Buncombe County Planning Board August 1, 2016

SUB2016-00274: Harlow L. Brown, P.E. on behalf of Doug Thompson applied for major subdivision approval of 14 lots for the project identified as Saddle Ridge Estates, and located on tax lot PIN # 9712-88-5975 (further described as un-addressed property to the east of 91 Cody Embler Road).

Buncombe County Planning Board Meeting Recommended Staff Conditions August 1, 2016 SUB2016-00274 (Saddle Ridge Estates)

Project No. 16029

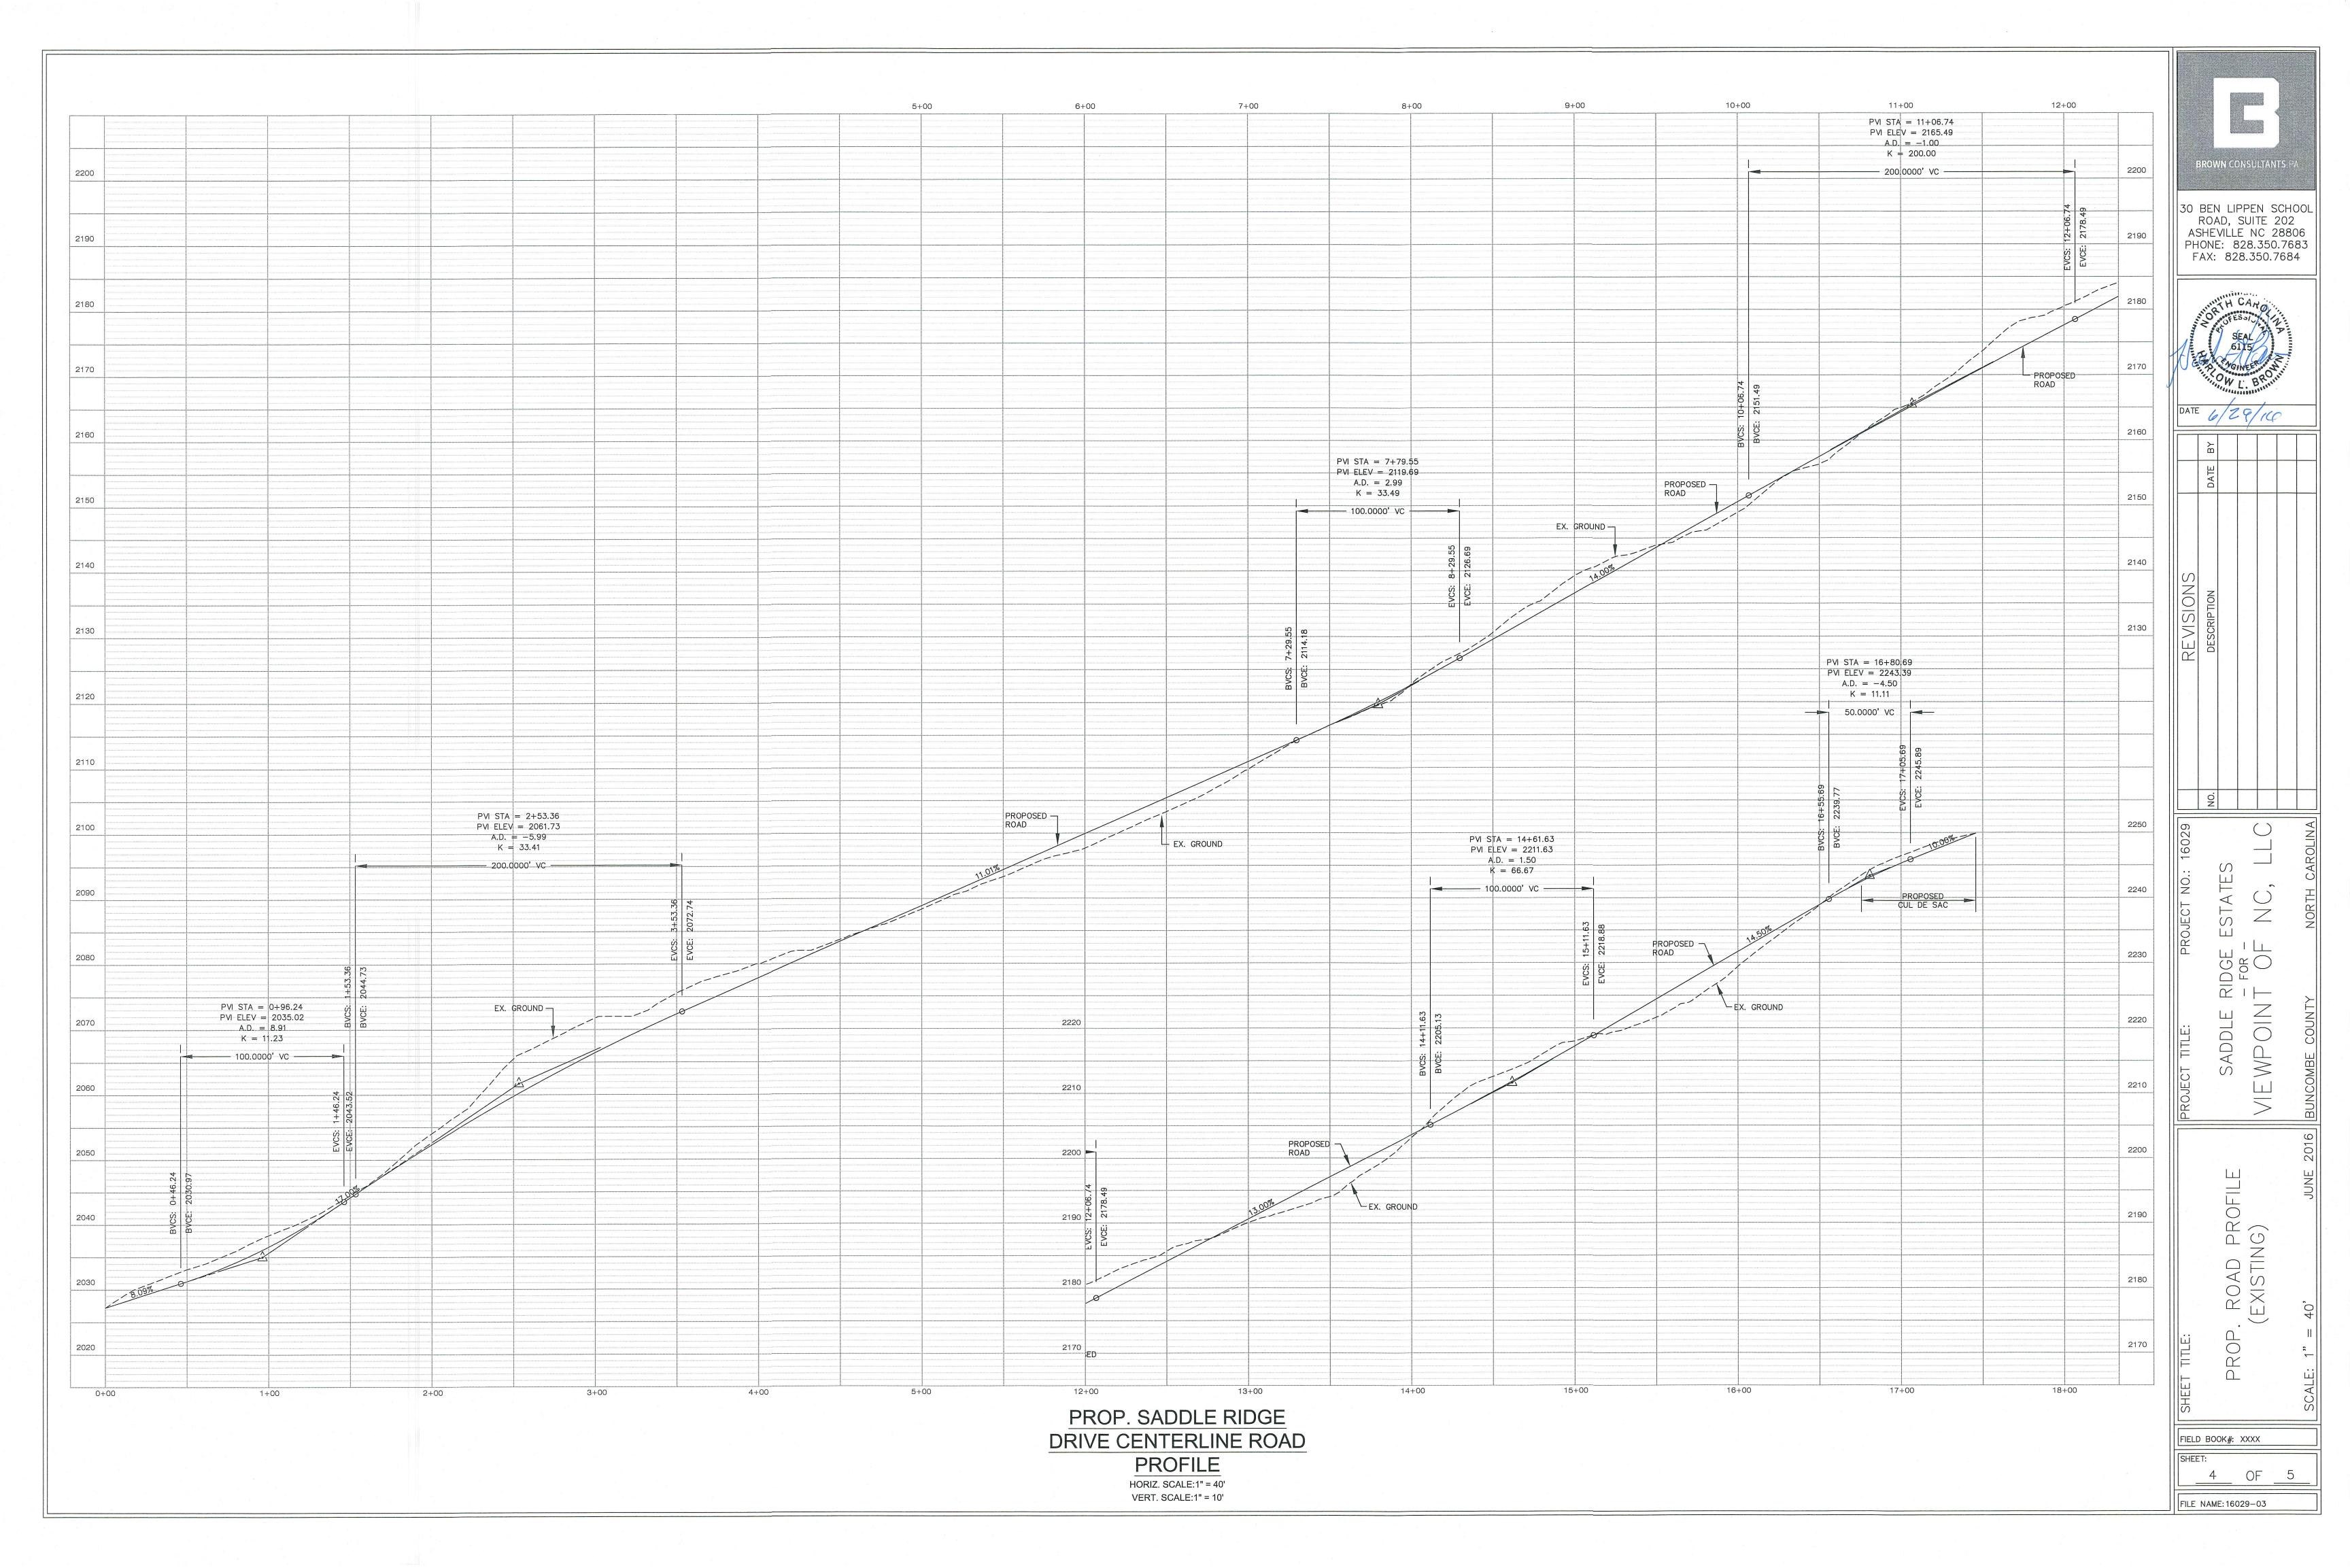
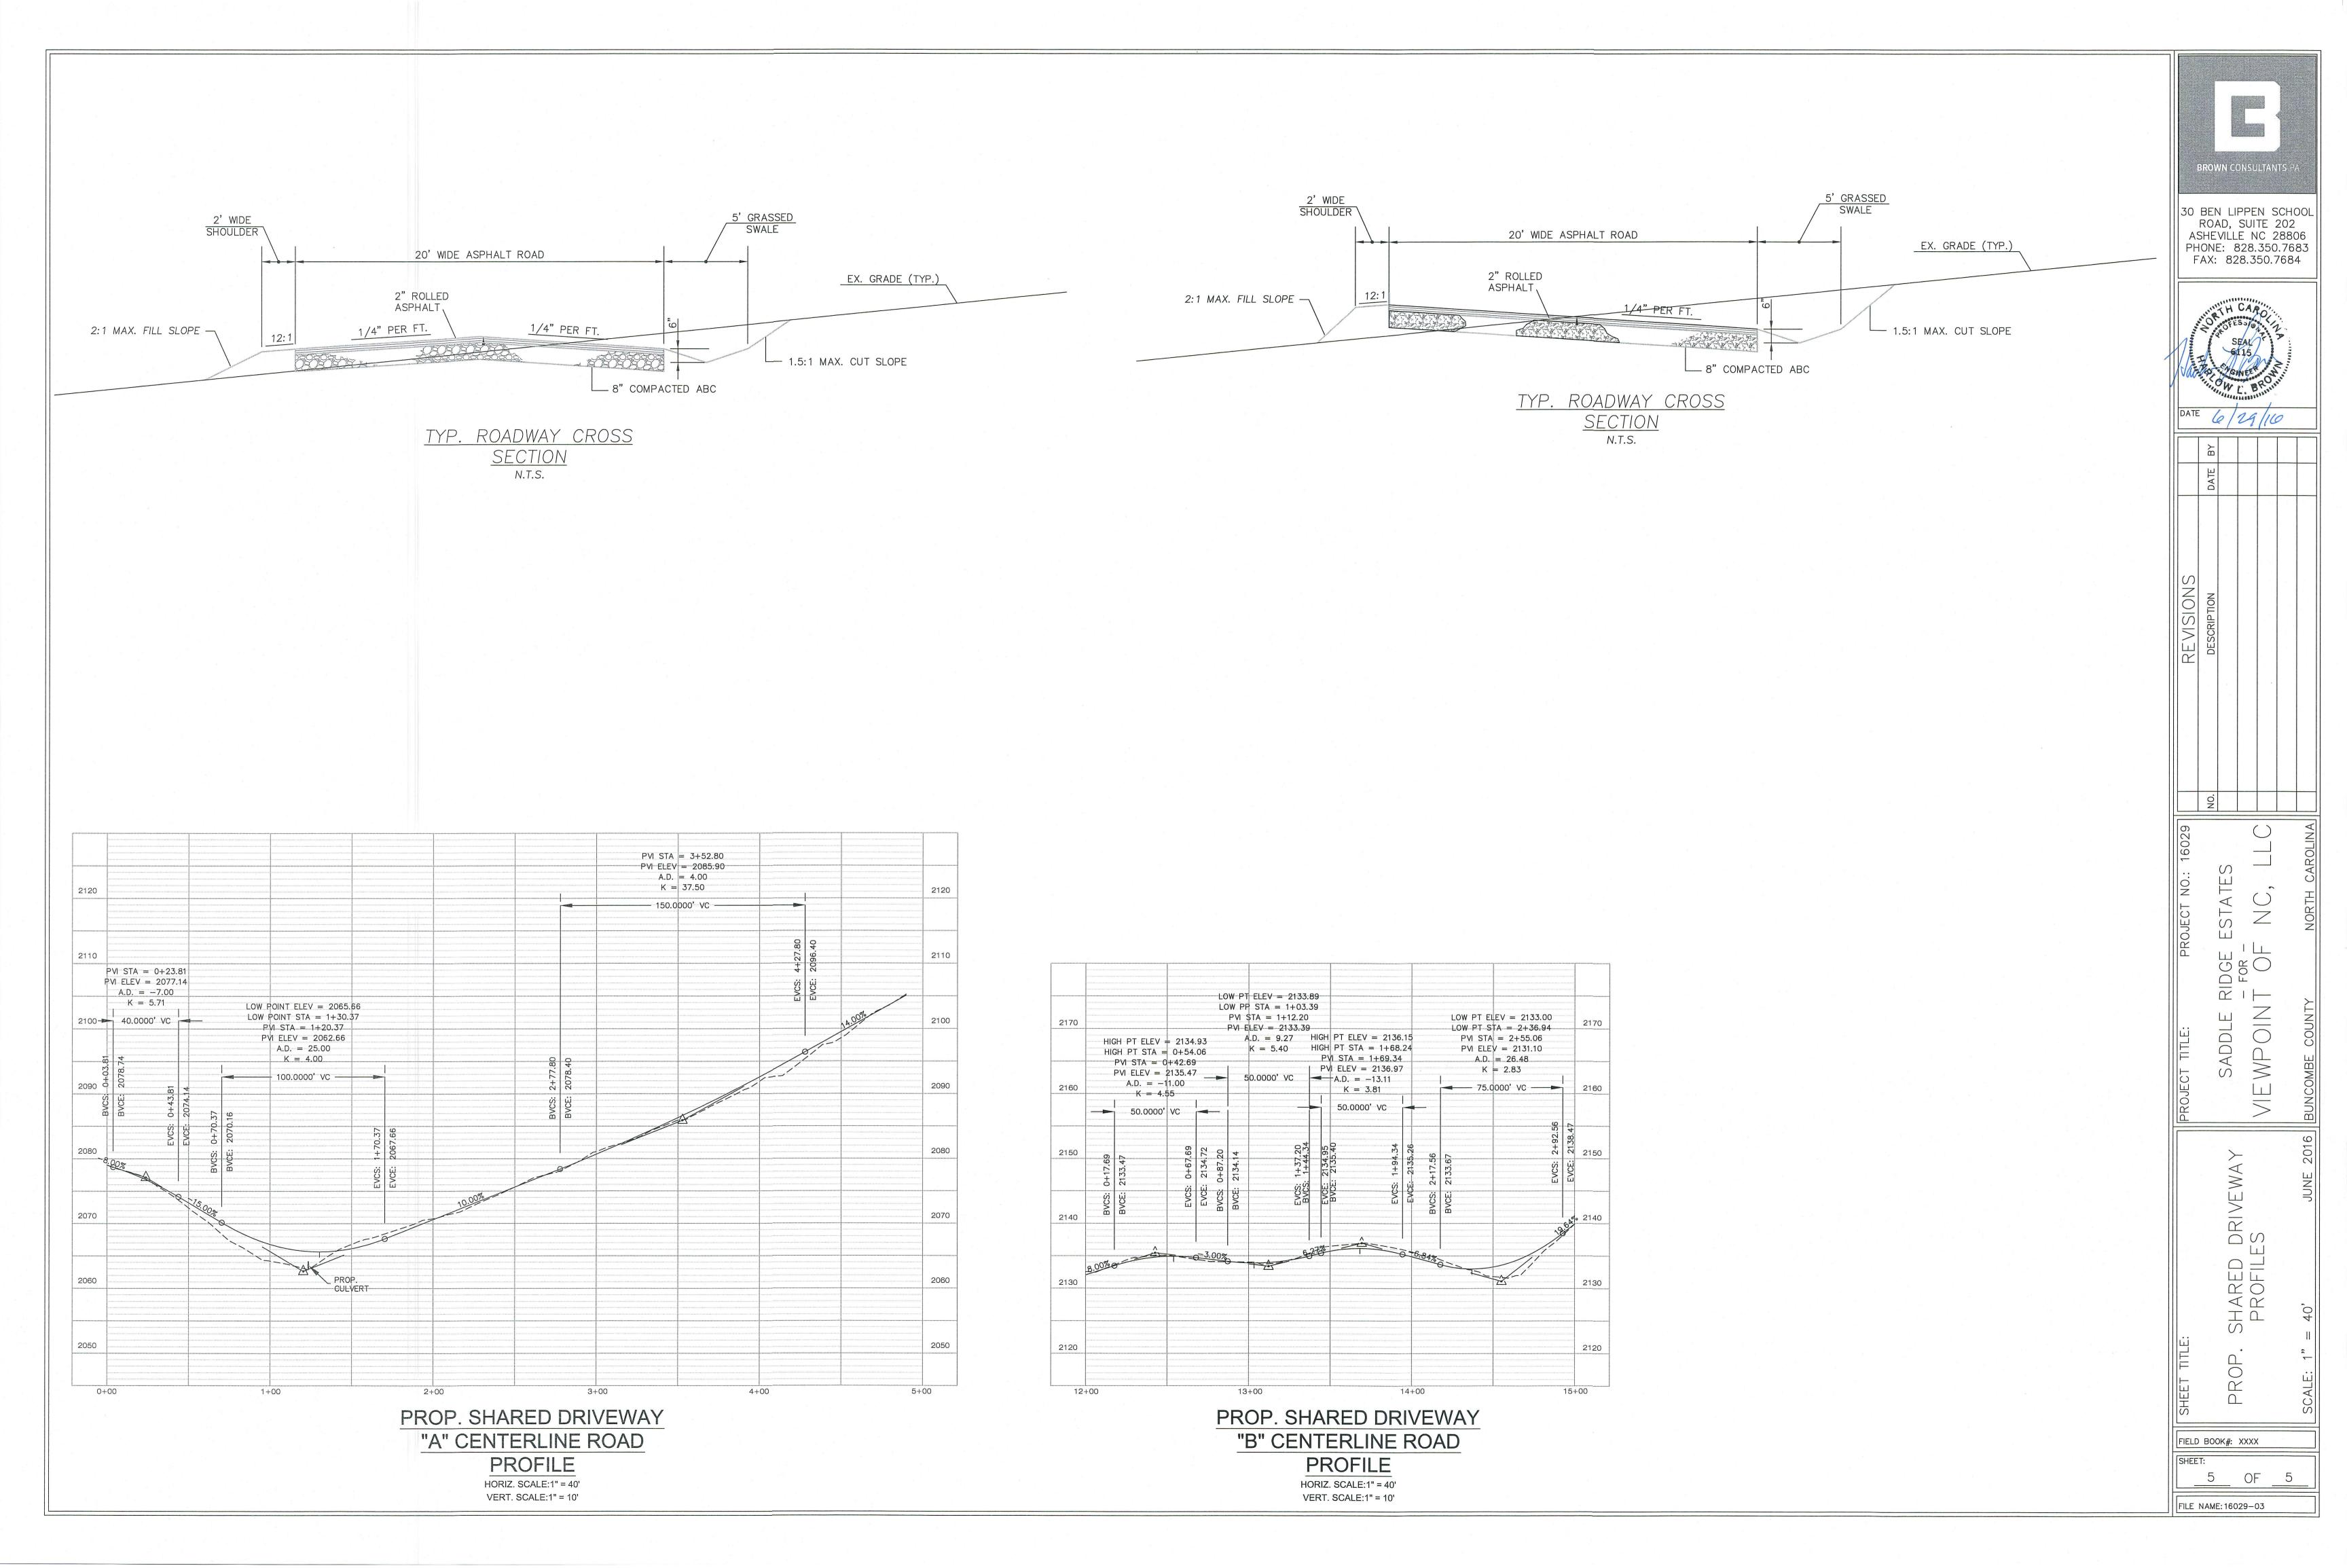
If approved by the Buncombe County Planning Board, the applicant shall provide the following information on a revised set of plans (if necessary) submitted to the Buncombe County Department of Planning and Development:

Provide proof of approval of E-911 addressing
 Provide a written statement from the Buncombe County Erosion Control Officer stating that an Erosion Control Plan has been has been submitted and approved for the project. No grading shall occur on the site until an approved Buncombe County Erosion Control permit is obtained.
 Provide a written statement from the Buncombe County Stormwater Administrator stating that the approved Stormwater Plan has been submitted and approved for the project. No grading shall occur on the site until an approved Buncombe County Stormwater Control permit is

4. Provide proof of a preliminary soils investigation that will evaluate the feasibility of developing a subdivision served by individual septic systems, which shall be prepared by a professional such as a soils engineer or soils scientist.

- 5. Indicate lot slope perpendicular to the roads for each lot or indicate that lot slope perpendicular to the road for all lots is less than 18%.
- Indicate FEMA floodplain map information on the submitted plan.Indicate address of property owners on submitted plan.
- 8. Indicate township on submitted plan.
- 9. Indicate township on submitted plan.
 9. Indicate provision of utilities, or indicate that no such provision are provided on submitted
- 10. Indicate approximate delineation of wooded and open areas on the submitted plans.

11. Indicate that no base course shall be placed on muck, pipe clay, organic matter or other unsuitable matter, and a minimum compaction rate of subgrade prior to paving shall not be less than 95 percent by standard proctor method and certified by a licensed engineer.
- 12. Indicate linear feet of roads on the submitted plans.13. Indicate existing use of the subject property on the submitted plans.
- 14. Indicate curve radii on submitted plan. Increase pavement width and base course where the road centerline is less than a 90-foot radius.

feet. Indicate that the corridor height does not exceed 60 feet on the submitted plans.

15. Provide proof of consultation with a geotechnical engineer for road construction in areas of a tract in excess of 30 percent natural slope and for all areas designated as High Hazard or Moderate Hazard on the Buncombe County Slope Stability Index Map prepared by the North Carolina Geological Survey or indicate that no such areas exist on the submitted plan.

16. Indicate that the road corridor does not exceed 90 feet in width along 80% of its total

length; up to 20% of the length of the road corridor may be graded to a maximum width of 135

17. Indicate construction of shared driveways on the submitted plans.
